RESPONSE TO REQUEST FOR ADDITIONAL INFORMATION

APR1400 Design Certification

Docket No. 52-046

RAI No.: 50-7911
SRP Section: 07.02 – Reactor Trip System
Application Section: 07.02
Date of RAI Issue: 06/23/2015

Figure 7.2-28 Functional Logic Diagram for Reactor Trip Signal Generation

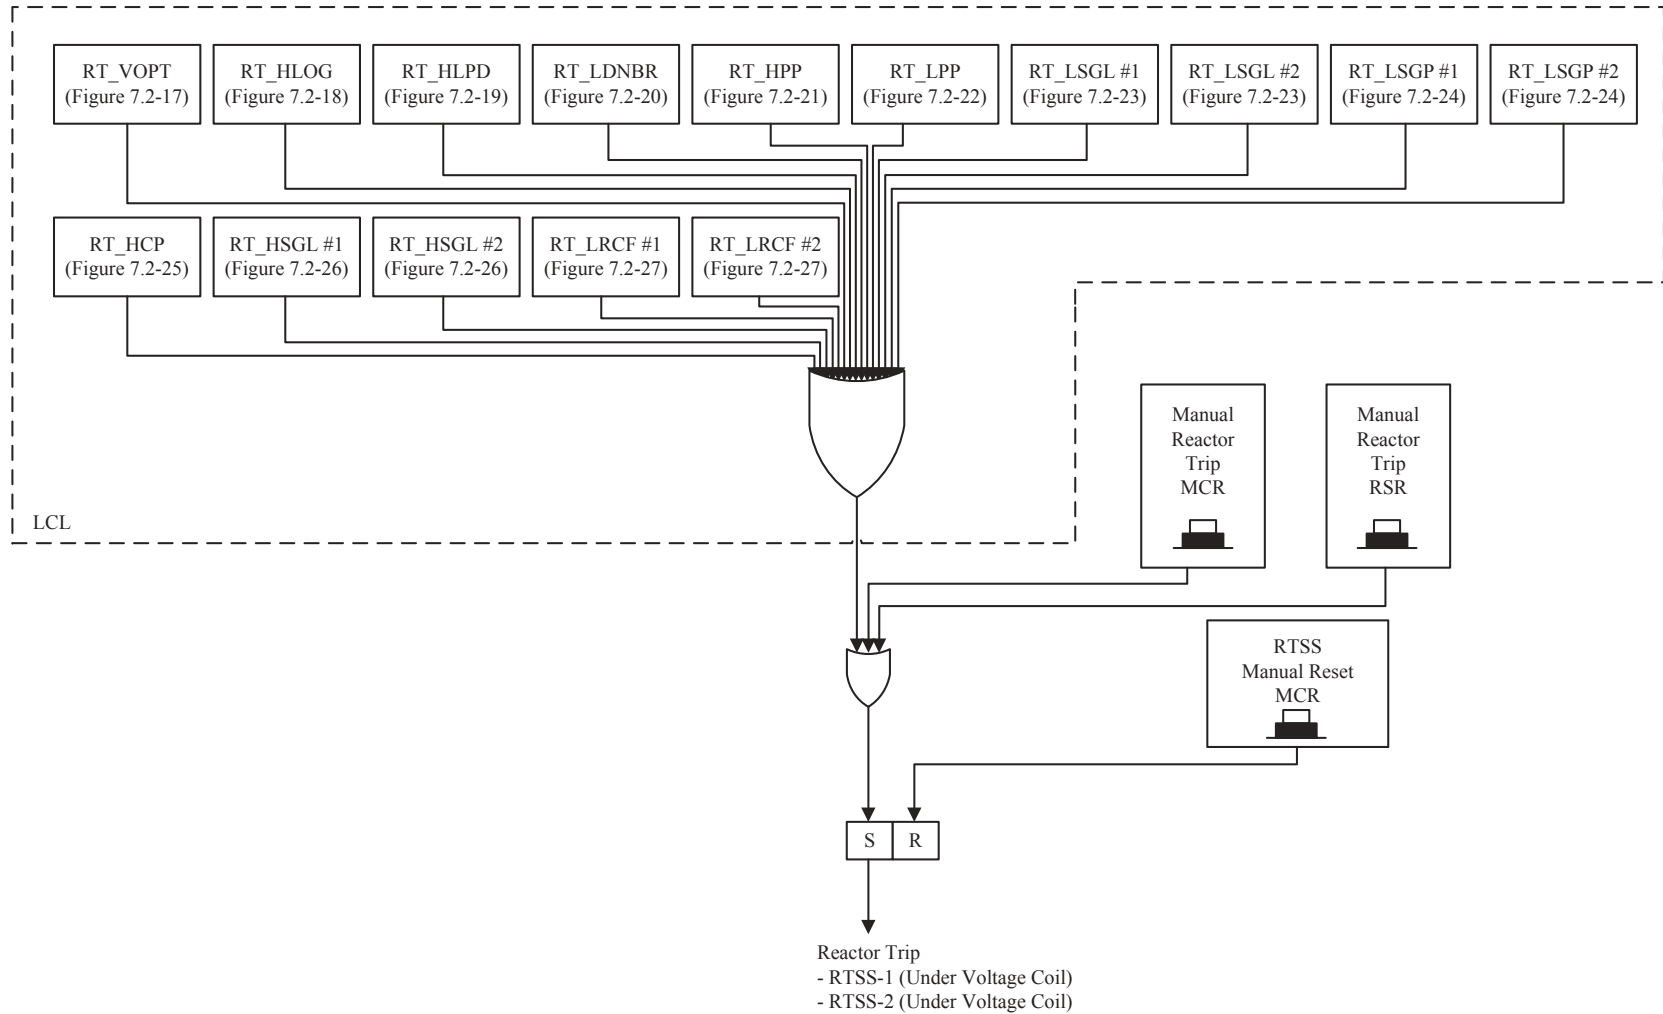
where the figures display only one division/channel (i.e., FSAR, Tier 2, Figure 7.2-10, “PPS Channel A Trip Path Diagram”) and where the schematics or diagrams of the figure display differences between the divisions/channels (i.e., FSAR, Tier 2, Figure 7.2-32, “Functional Logic Diagram for CWP”), insert a caption on the figures explaining whether the schematic or diagram shown is identical for all divisions/channels or insert a caption that describes what the differences are between the divisions/channels.

The description of identification is inserted into Figure 7.2-28 of DCD Tier 2 as shown in the attached mark-up for the case where some portion of the diagram shown in the figure is specific to certain channels or divisions. In this case, the manual reactor trip in RSR is applicable only for PPS divisions A and B. The remaining portion of the diagram in this figure is identical for all PPS divisions.

Note:

The manual reactor trip switches in the RSR are provided only for divisions A and B.

Figure 1 Redundancy in CPCS

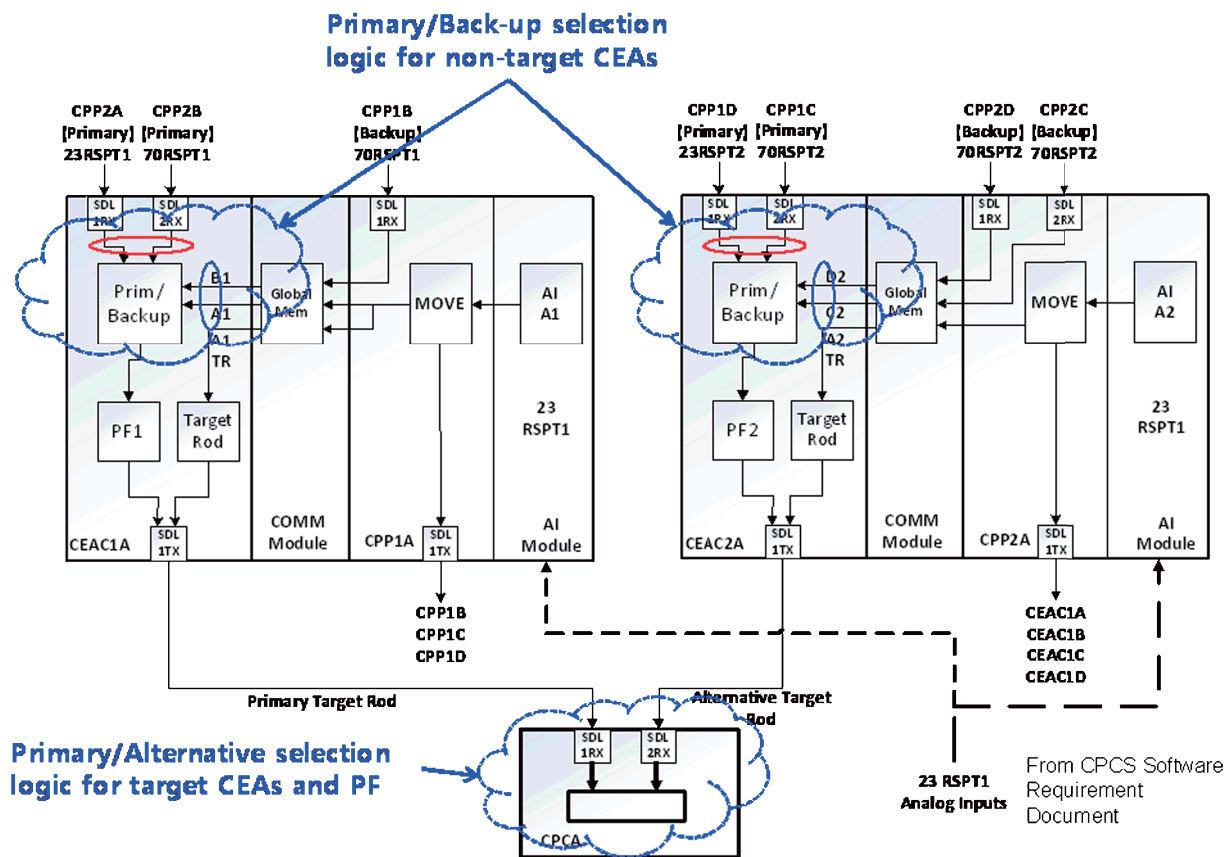
Provide design information that would:

d) In the core protection calculation system (CPCS) channel, there are two selection logics as shown in Figure 1. One is the primary/back-up selection logic for the non-target CEAs in the CEAC processor. The other is primary/alternative selection logic for the target CEAs and PF in the CPC processor.
